**Docket Item #9A-G**  
**Master Plan Amendment #2010-0004**  
**CDD Concept Plan Amendment #2010-0001**  
**Amendment to the Potomac Yard Urban Design Guidelines**  
**Text Amendment #2010-0004**  
**Development Special Use Permit #2010-0012 (Landbay K)**  
**Development Special Use Permit #2010-0021 (Landbays I&J East)**  
**Special Use Permit #2010-0033 (Pedestrian Bridge)**  
**Special Use Permit #2010-0058 (Landbay D)**  
**Multiple Addresses – Potomac Yard Amendments**

<b>Application</b>	<b>General Data</b>	
<b>Project Name:</b> Potomac Yard	PC Hearing:	October 5, 2010
	CC Hearing:	October 16, 2010
	If approved, DSUP Expiration:	October 16, 2013 (3 years)
<b>Location:</b> Multiple Addresses	Zone:	CDD#10 with underlying zones of RB, CSL, I, and UT
	Proposed Use:	Mixed Use
<b>Applicant:</b> Potomac Yard Development, LLC, and RP MRP Potomac Yard, LLC; represented by M. Catherine Puskar	Small Area Plan:	Potomac Yard/Potomac Greens
	Historic District:	Old and Historic Alexandria along George Washington Parkway in Potomac Greens (Landbay A)
	Green Building:	As previously approved in the applicable DSUPs.

**MPA #2010-0004  
CCD #2010-0001  
TA #2010-0004**

**DSUP #2010-0021  
DSU

Amended CDD concept plan showing boundaries of CDD #10

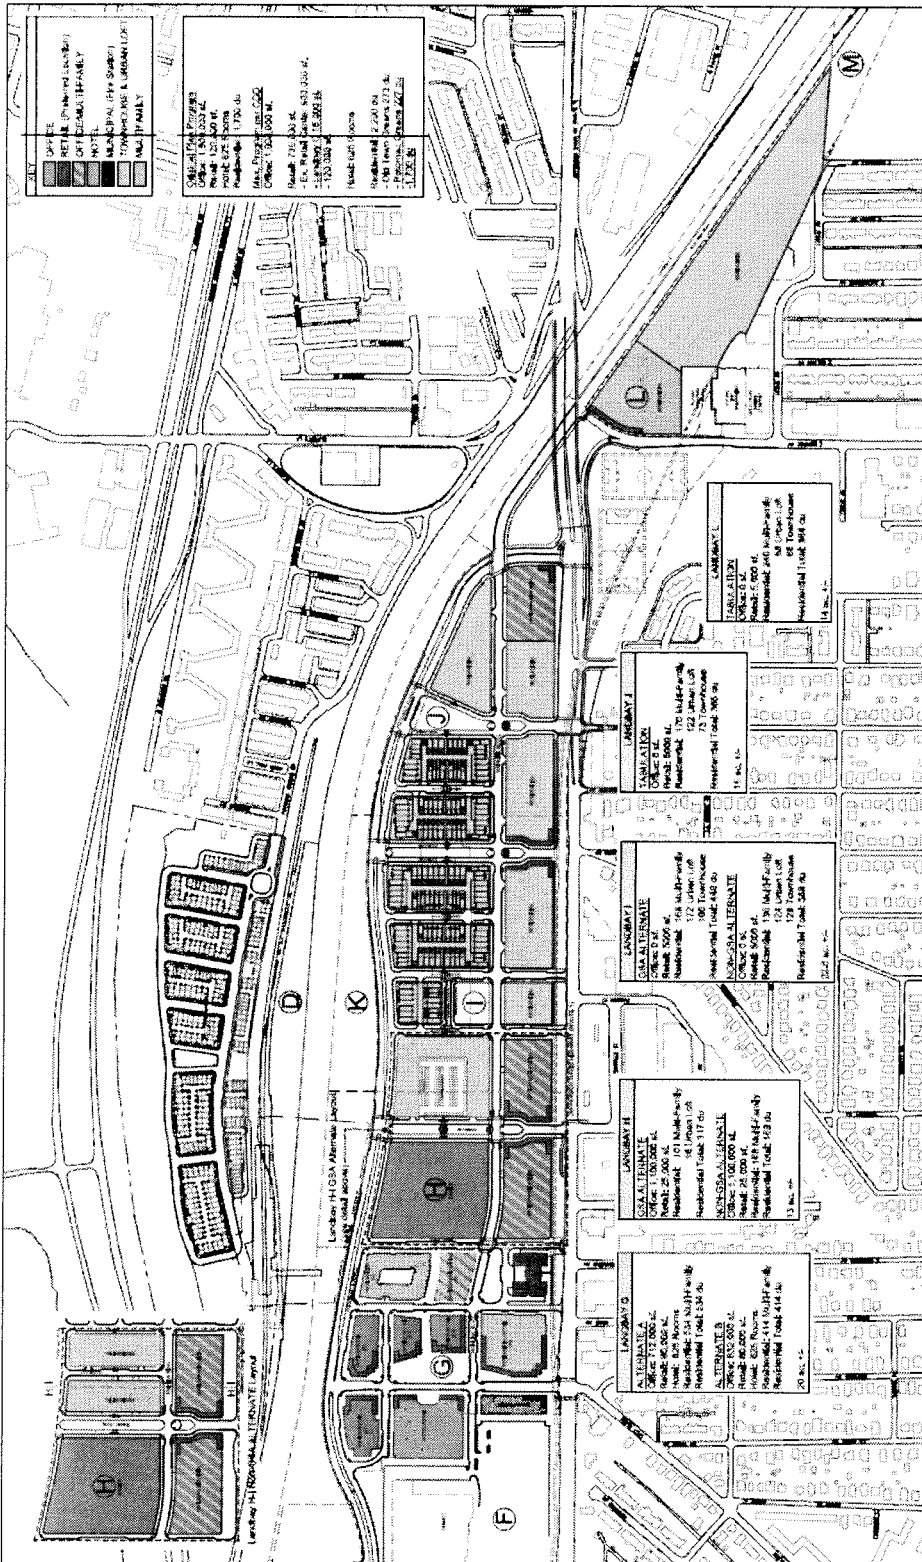
Earlier this year, Landbay F was rezoned to CDD #19 to reflect new master planning of the current retail center into an urban town center focused on the relocated Metrorail station. An amended CDD concept plan has been created to show the new boundaries of CDD #10 as part of this review. (Attachment 1)

# Appendix H ii: Proposed Predominate Height Limits

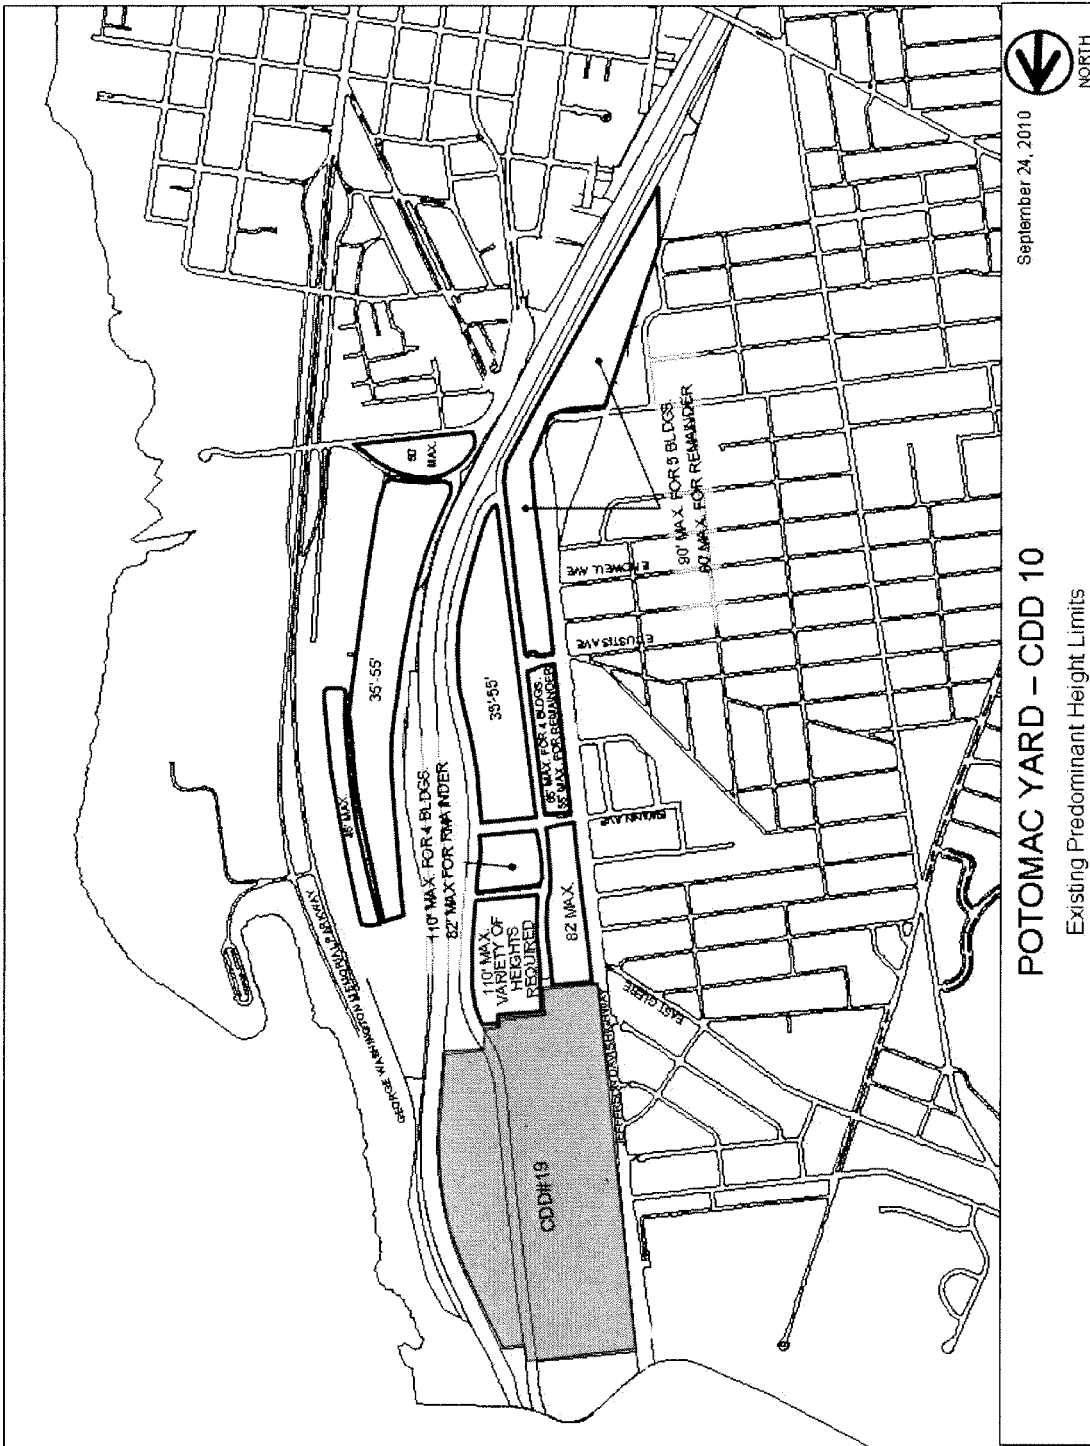
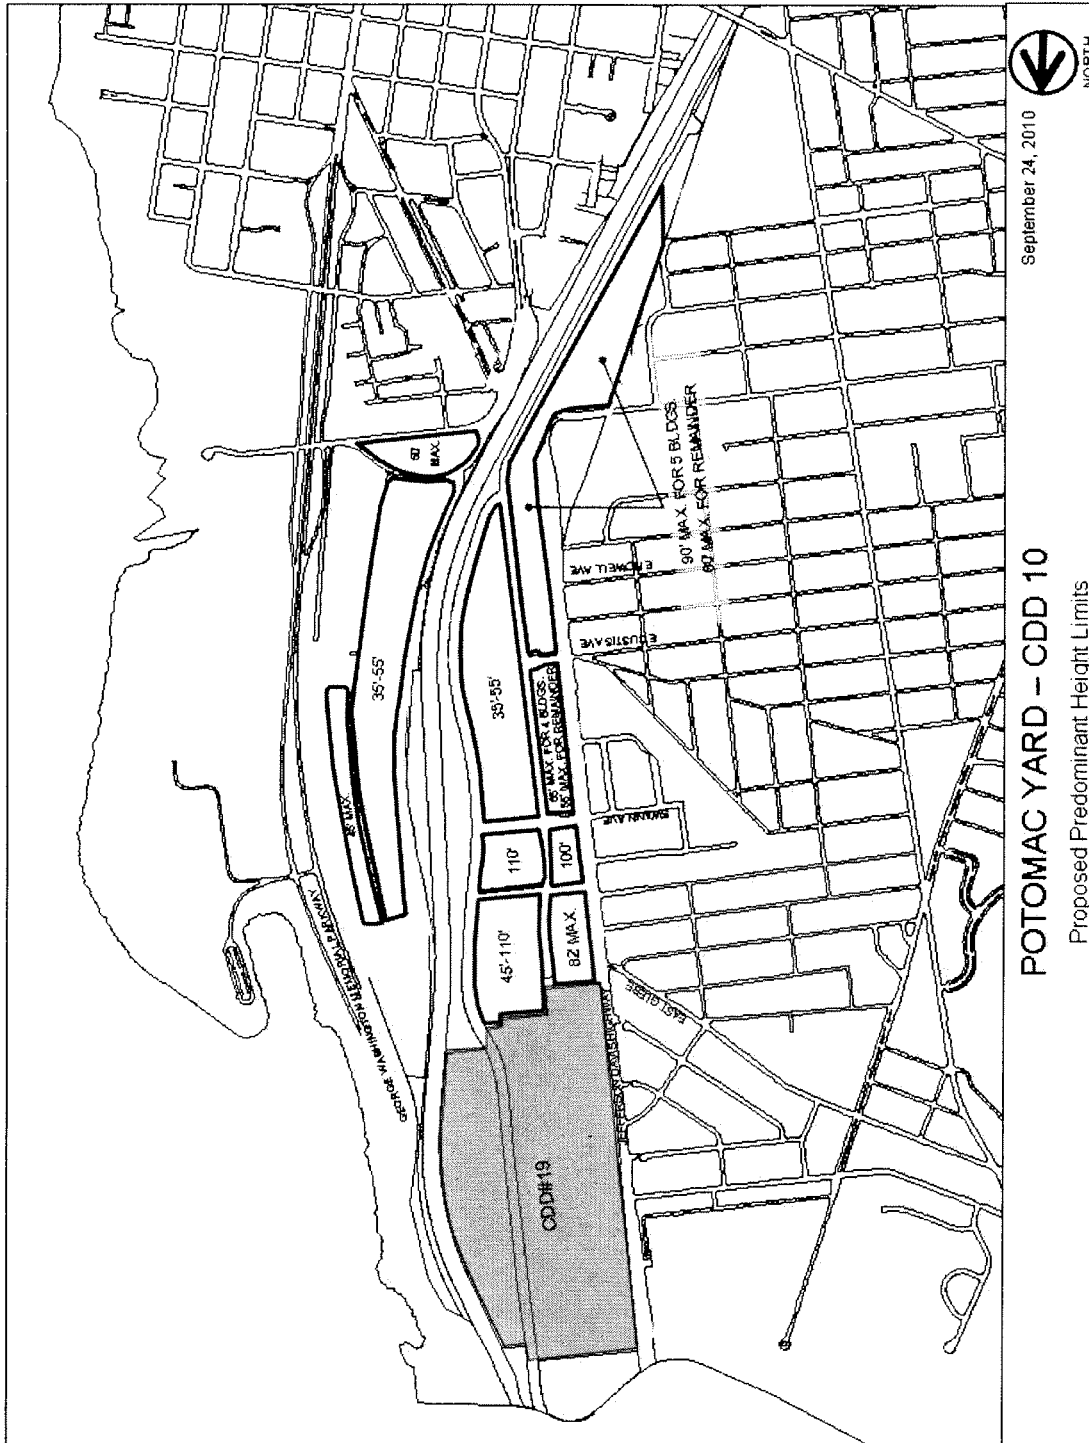
Staff agrees with the 100 foot building height for all of Landbay H's Route 1 frontage, but believes that the areas in Landbays I and J between Windsor and the northern boundary of Landbay I should be limited to 75 feet. In fact, the majority of this area is currently being reviewed by staff as a Concept Plan and the development proposed is stacked townhouses – which will easily fit within this height limit. Staff believes that the currently approved height of 90 feet from Windsor Avenue south to the end of Landbay L should be retained. (Appendix H)
